HISTORIC AND DESIGN REVIEW COMMISSION

June 17, 2015

HDRC CASE NO: 2015-241
ADDRESS: 131 Huizar
LEGAL DESCRIPTION: NCB 7676 BLK LOT 26
ZONING: C2NA H
CITY COUNCIL DIST.: 3
DISTRICT: Mission Historic District
APPLICANT: Mark Tolley
OWNER: 210 Development Group
TYPE OF WORK: New construction of six apartment buildings
REQUEST:

BUILDING TYPE | EXTERIOR ELEVATIONS

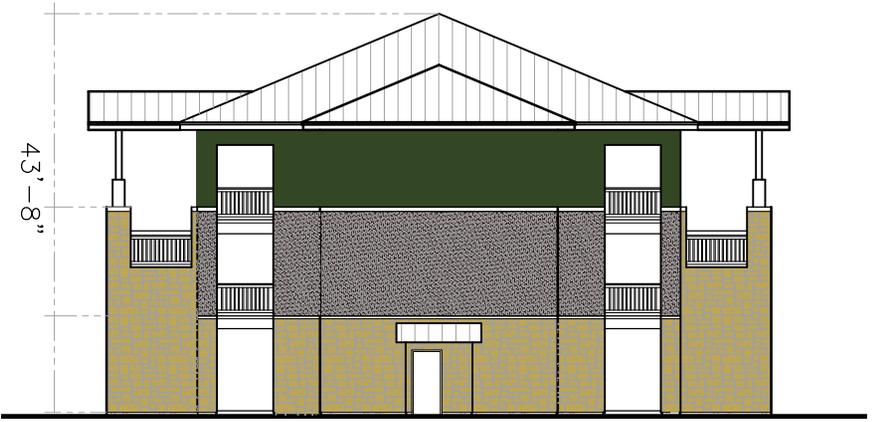
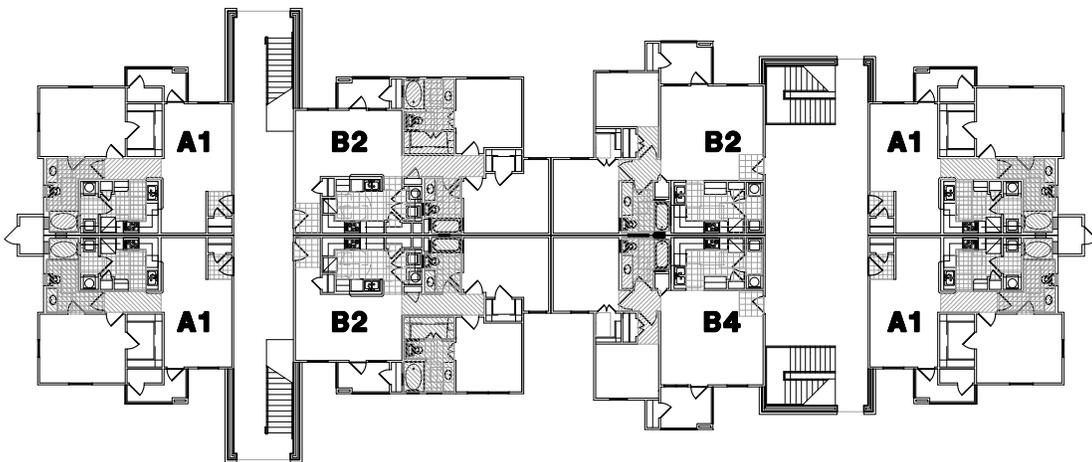
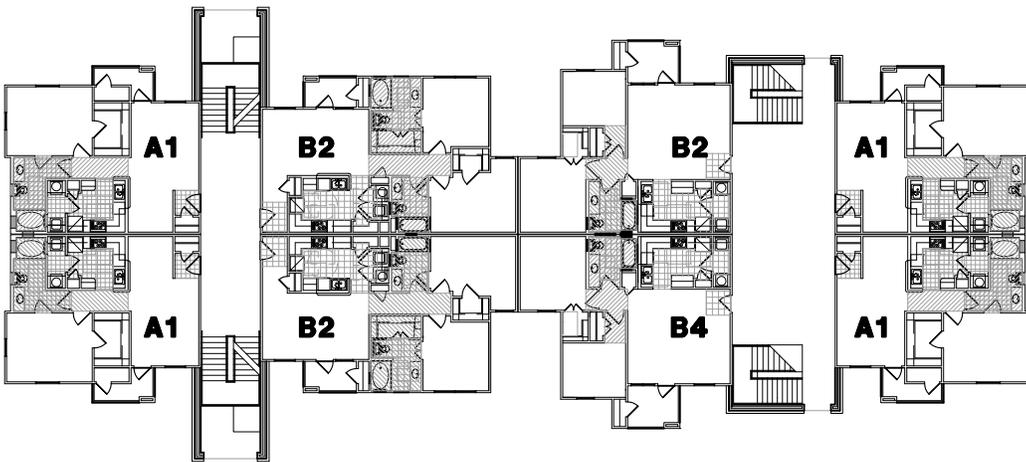
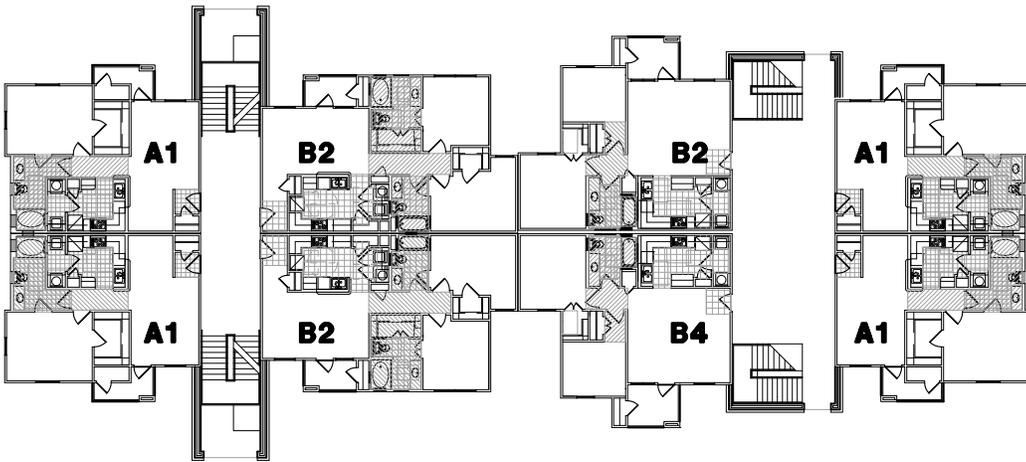
- d. According to the Guidelines for New Construction 2.A., new construction in historic districts should feature a similar height and scale as the surrounding structures. At three stories, featuring no distinguishable architectural element to serve as a transition from a taller height to the height of precedent, typically one or one and a half stories, the applicant's proposed height is not consistent with the Guidelines.

- g. According to the Guidelines for New Construction 2.C.ii., horizontal façade elements should align with those found in nearby historic buildings. A base, middle and cap should be established to conform to the established precedent. The applicant has integrated various design elements that separate the façade into three sections including a change in materials, a change in color and a variation of floor heights. This is consistent with the Guidelines.

- h. The applicant has proposed materials that appear to include a stone façade, stucco, Hardi Board siding and a standing seam metal roof. Generally these materials are consistent with the Guidelines for New Construction 3.A.i., however staff recommends additional information regarding the detailing of both the Hardi Board siding and the stone found at the street level.

Staff does not recommend conceptual approval at this time based on findings a through m. Staff recommends that the applicant develop a site plan that features a consistent orientation for the proposed structures and features screened parking. In addition to this, staff recommends that the applicant resolve design issues regarding the lack of the height transition as stated in finding d, that the applicant provide information regarding the detailing of each façade material, that the applicant provide information regarding the location and screening of mechanical equipment and that the applicant
